INDIANA DEPARTMENT OF TRANSPORTATION

STANDARDS COMMITTEE MEETING AGENDA

RE: Agenda for the May 18, 2006 Standards Committee Meeting

306.08 Transition Milling

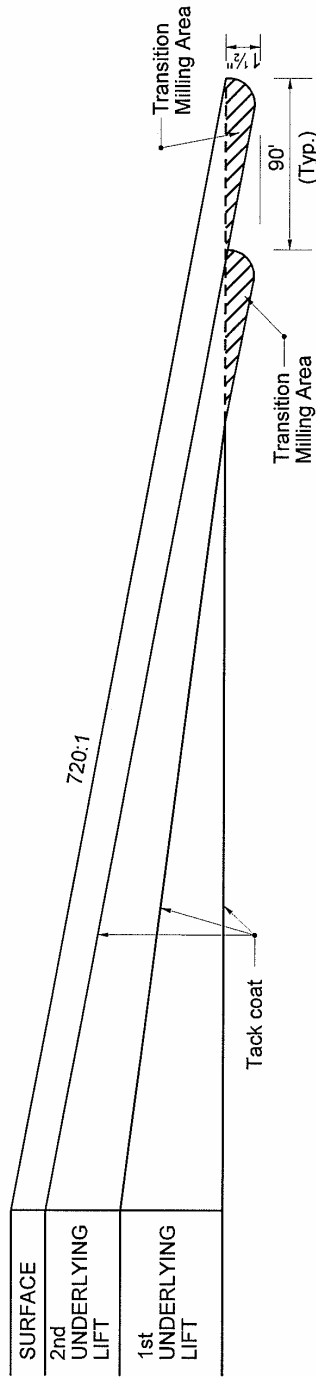
Transition milling shall consist of cutting a wedge at the beginning and ending of projects, and paving exceptions. The existing pavement shall be cut to provide a *nearly* vertical face of 1.5 in. (38 mm) for the termini of each overlay lift of base, intermediate, or surface. The existing pavement shall be milled at a rate of 720:1 or as directed to achieve

Figure 72-3B

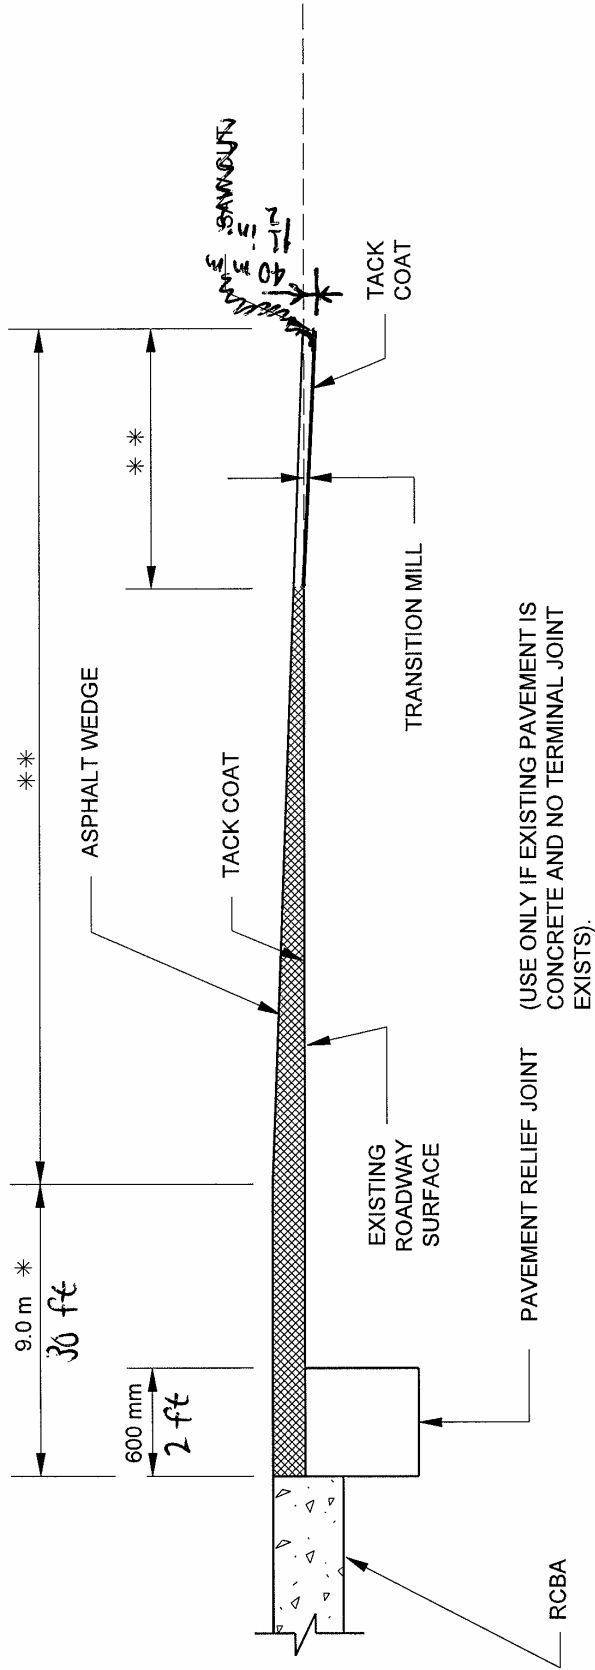
Figure 72-3B, Pavement Transition Detail

707-SDPC-01, AASHTO Type II, III, or IV I-Beams
707-SDPC-02, Indiana 54" Bulb-Tees
707-SDPC-03, Indiana Bulb Tees Greater Than 54" in Depth

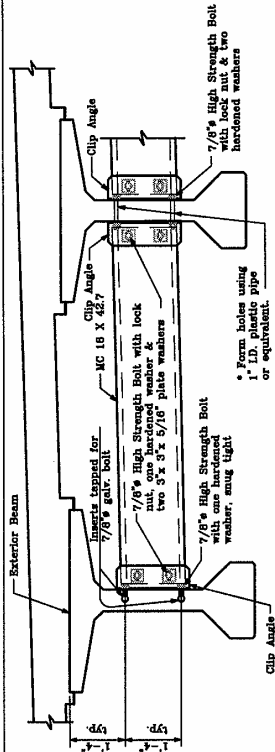
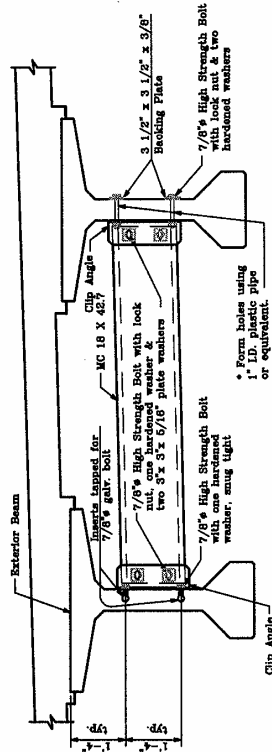
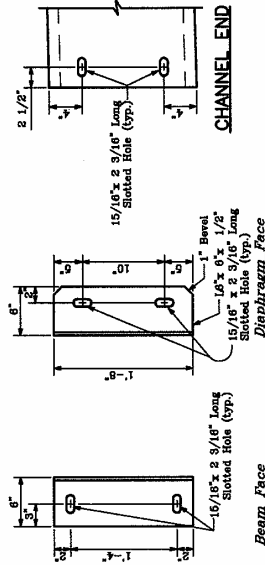
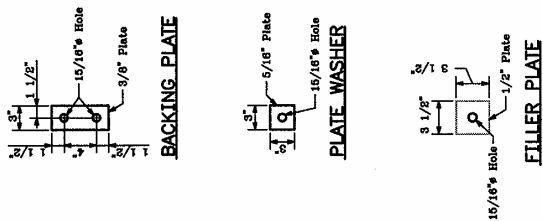
The contractor will be permitted to substitute structural-steel interior diaphragms for those of cast-in-place concrete in each prestressed-concrete members bridge. The substitution of steel for concrete does not affect the bridge design. Concrete diaphragms should continue to be specified, detailed, and quantified on the plans.

The use of structural steel intermediate diaphragms will be allowed as an alternate to the concrete interior diaphragms shown on the plans. All structural steel shall be fabricated and erected in accordance with 711. Steel diaphragms shall include all connection angles, plates, and associated hardware required for a complete installation. The Contractor shall replace, re-galvanize, or repair all damaged galvanized material at the discretion of the Engineer.
